**From:** [Adam Trimble](#)  
**To:** [Julie Adams](#)  
**Subject:** RE: Questions for the LMN consultants: Columbia Theatre Certificate of Appropriateness - ActionItem:00007:hopqL  
**Date:** Tuesday, May 06, 2008 8:31:34 AM

**From:** Adam Trimble [mailto:[adam.trimble@ci.longview.wa.us](mailto:adam.trimble@ci.longview.wa.us)]  
**Sent:** Friday, April 25, 2008 12:06 PM  
**To:** Julie Adams  
**Cc:** Steve Langdon; John Brickey  
**Subject:** FW: Questions for the LMN consultants: Columbia Theatre Certificate of Appropriateness

Columbia  
Theatre Chiller

Sheet Title

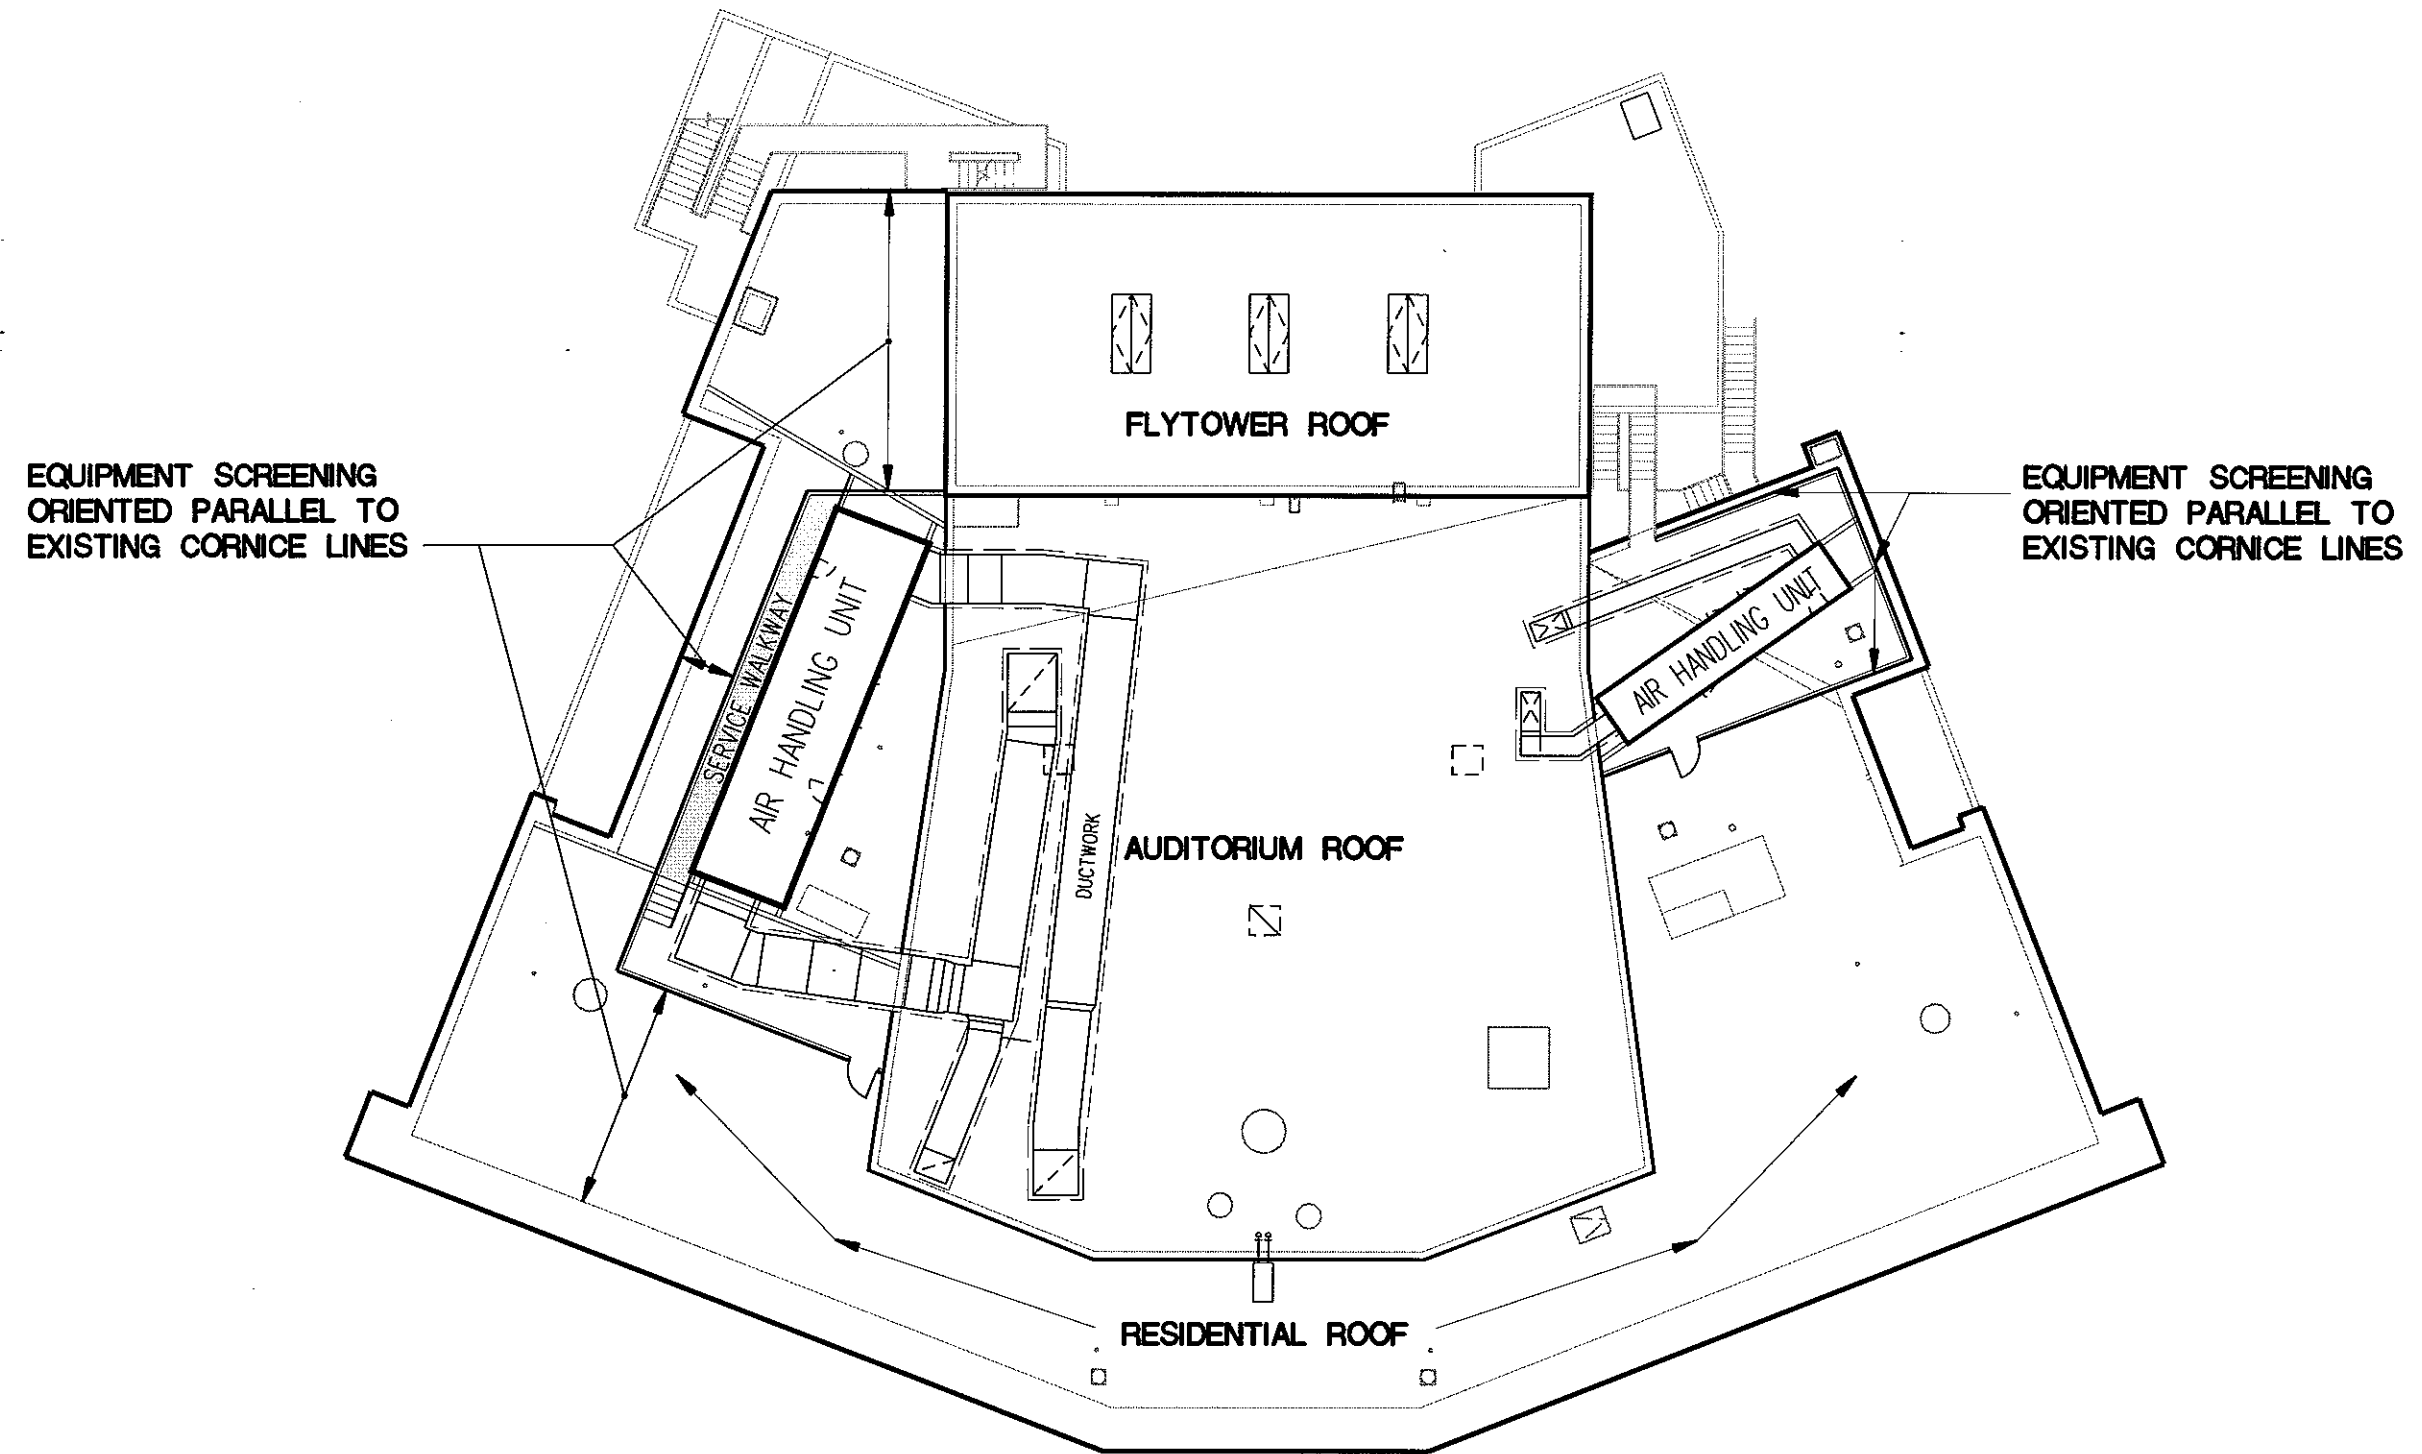
- 2) Mr. Hanna also asked about the proposed fencing around an optional proposed air conditioning unit to be located in the parking lot. Questions were raised about noise levels, the visual aspects of the screen or masking fence, and the impact on the parking stall count. More information on this AC unit proposal is desired.

- a. Commission desires total compatibility with the existing facades...

- b. Commission would like to see notation that the proposal is sensitive to, and accommodating of, the tenants and surrounding businesses.

**LMN Response:** *We are working to finalize details that will meet these suggestions.*

## COLUMBIA THEATRE - ROOFTOP MECHANICAL SCREENING PROPOSAL

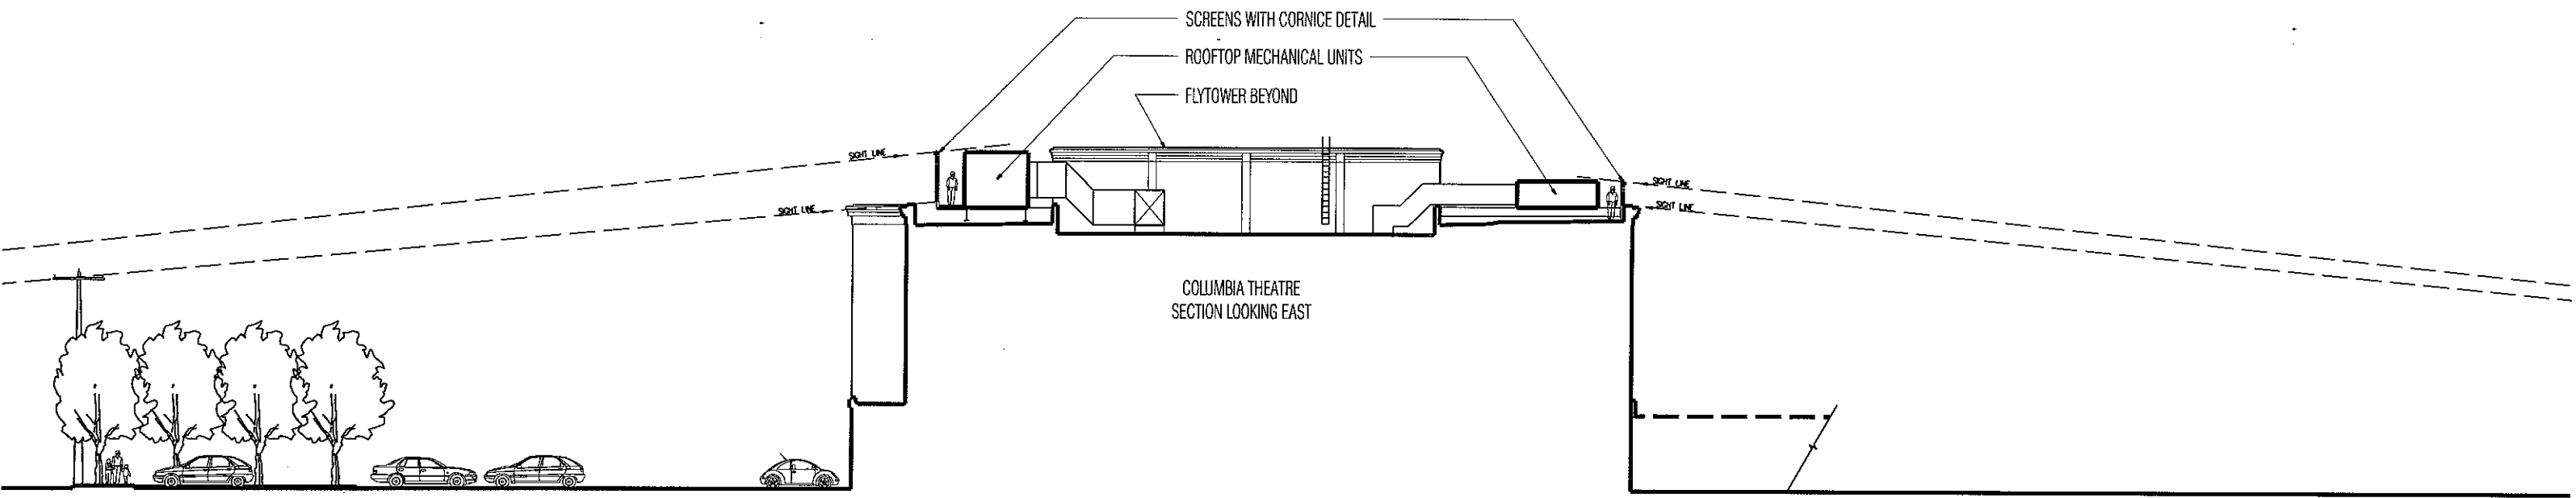
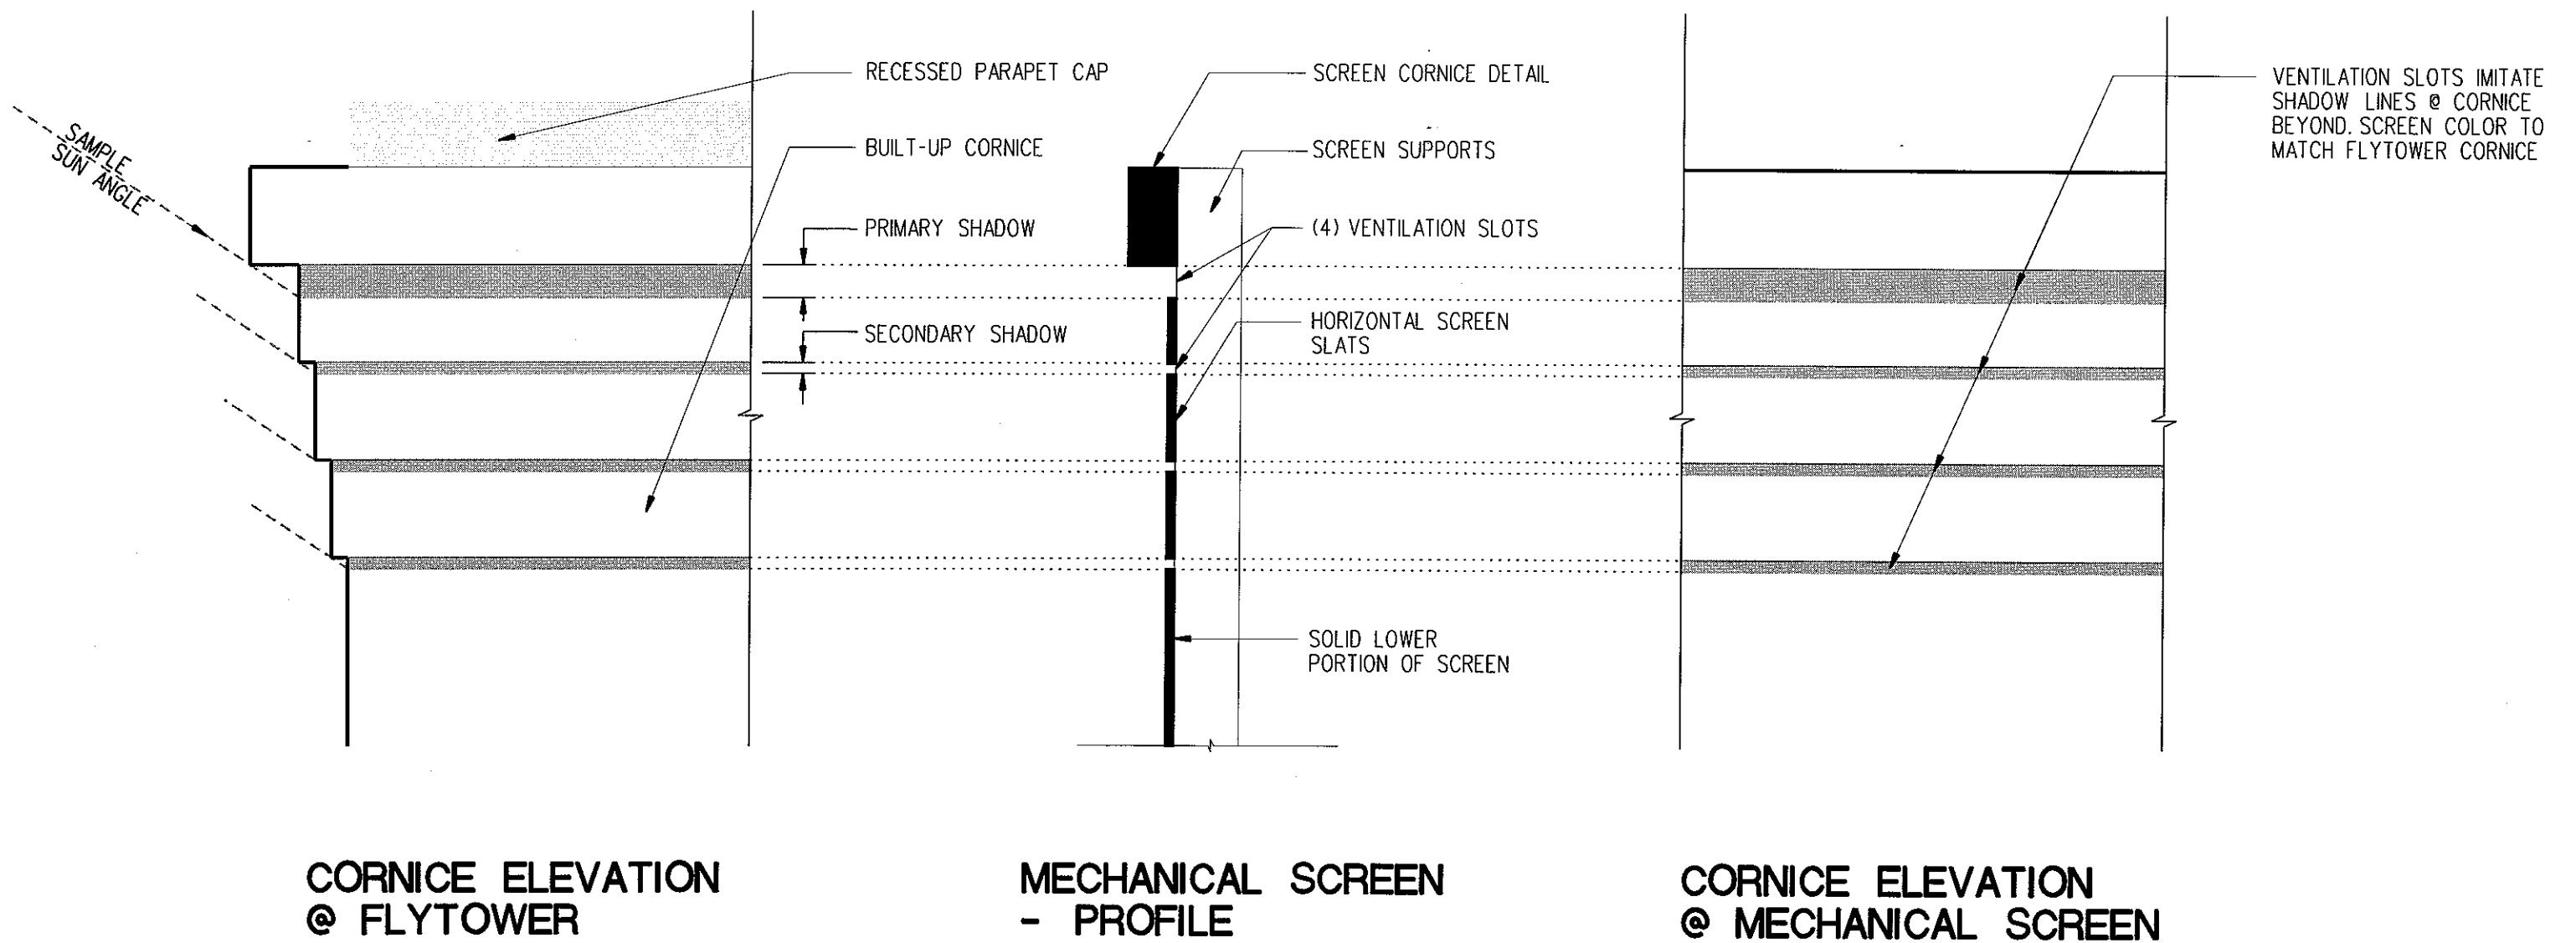
- 5) Mr. Thomas Hill and other commissioners noted concerns about the roof top mechanical screening walls. The commission would like to see textural options for the walls.

a. Exterior façade critical to the historic preservation commission.

b. Please give a complete overview of the changes to the façade including; detail on the mechanical installations, the visual impact on the building from the street and from the apartments. Including also, details on the air intake- located on the north roof (of the pepper theater).

**LMN Response:** *We agree with the assessment that the exterior mechanical screen walls should relate to the existing building. Please see attached plans, sketches and details that have been developed to illustrate the proposed design.*
